REQUEST FOR PROPOSAL No. 23-010

Supply and Install of Prefabricated Campground Office Building

Addendum 2
Issued: February 21, 2023

APPENDIX 2: UTILITY AND BUILDING LOCATIONS

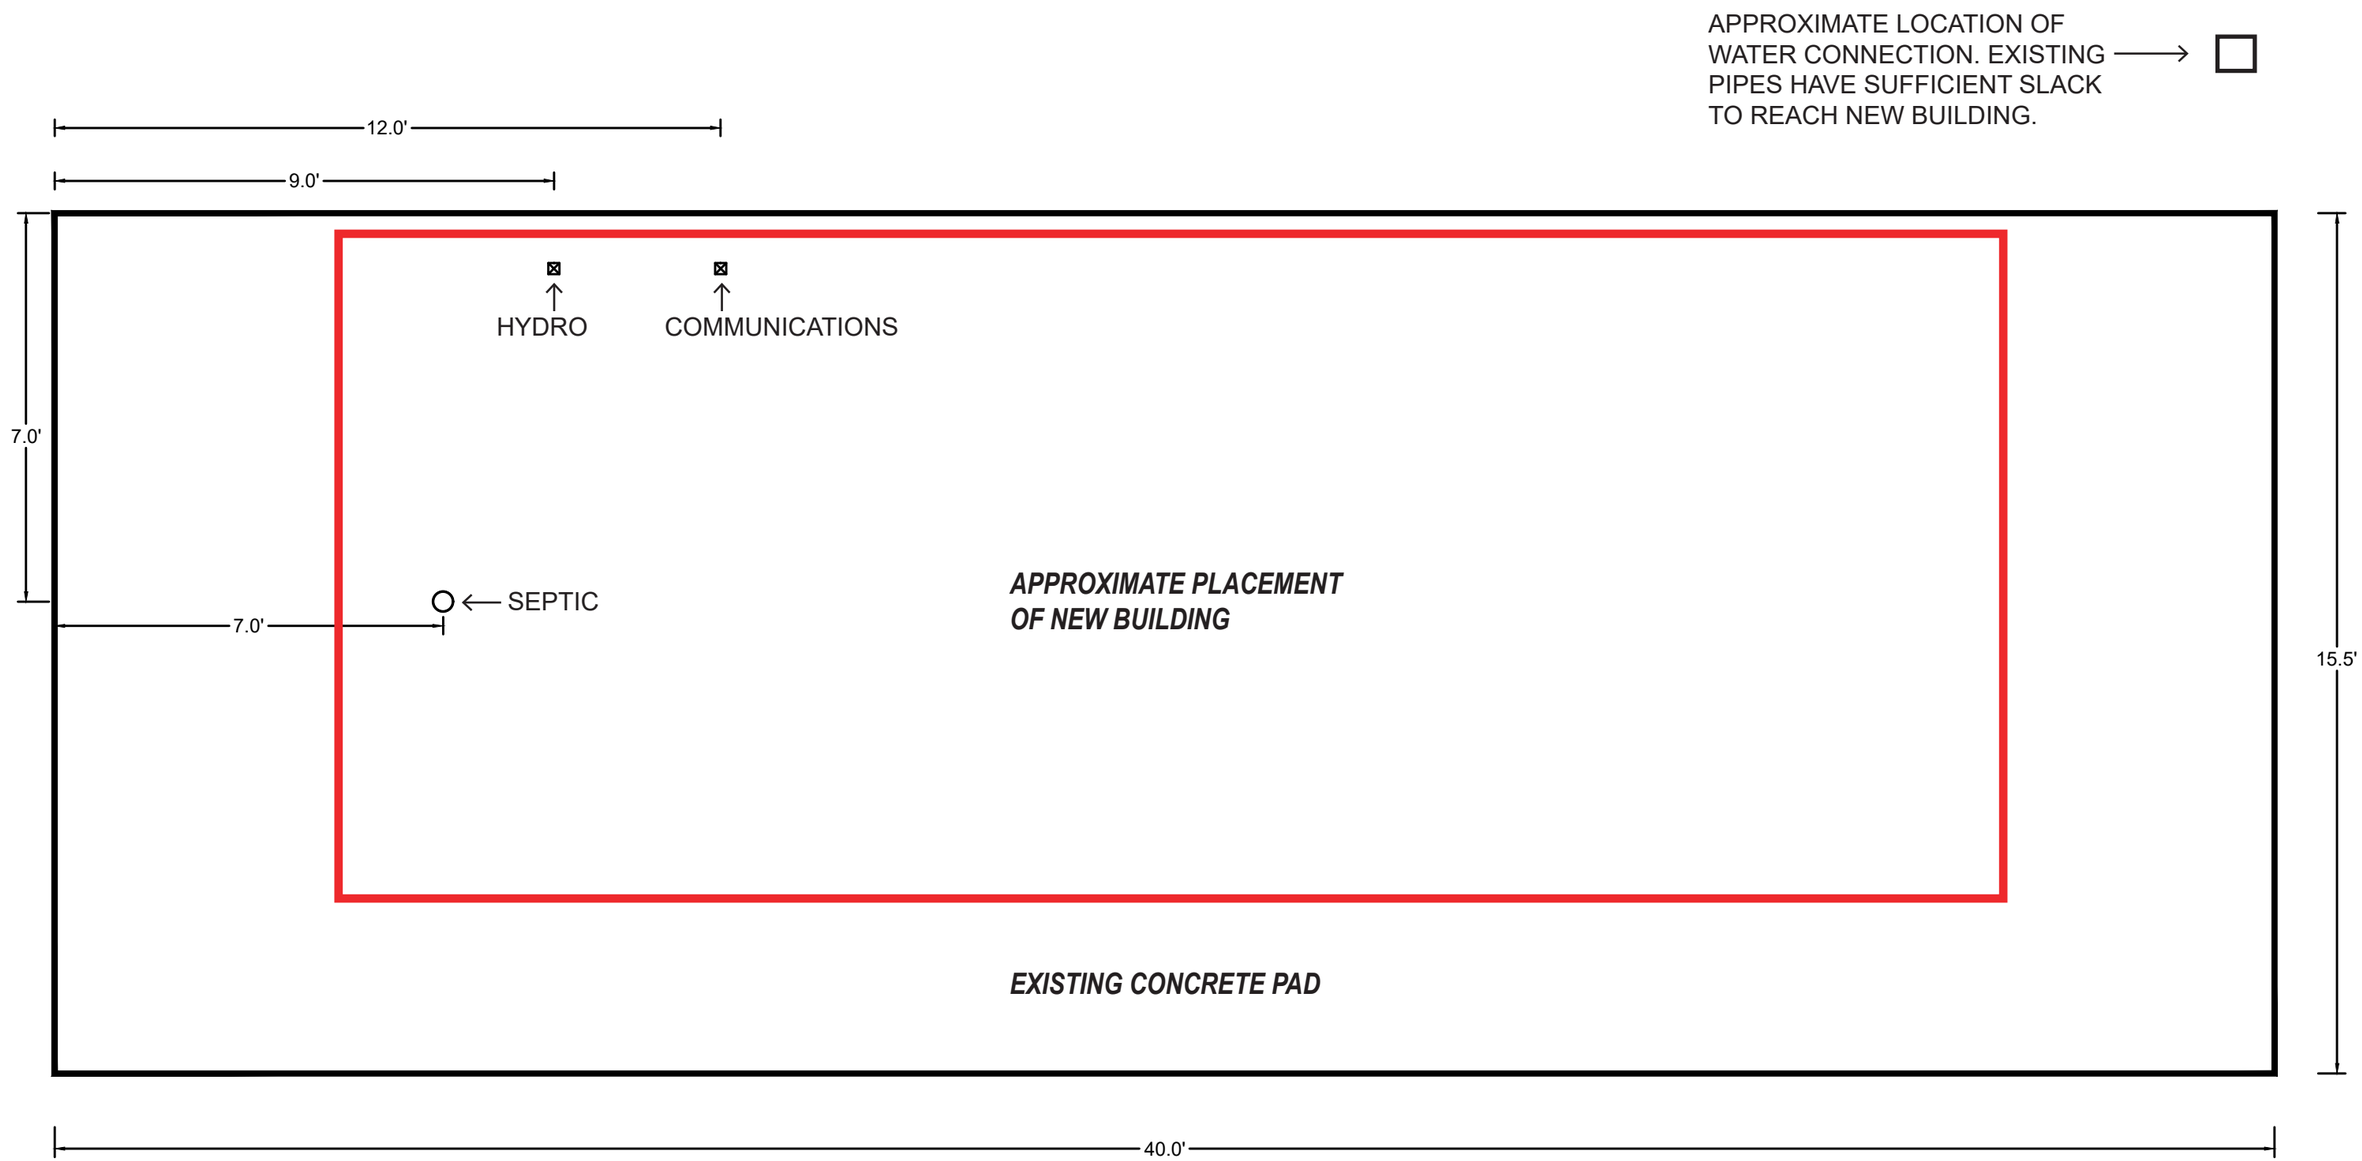
Question #1
On the concrete pad supplied by client for the building. Where are the utilities located that you would be tying into our building.

Response #1
See attached for Appendix 2.
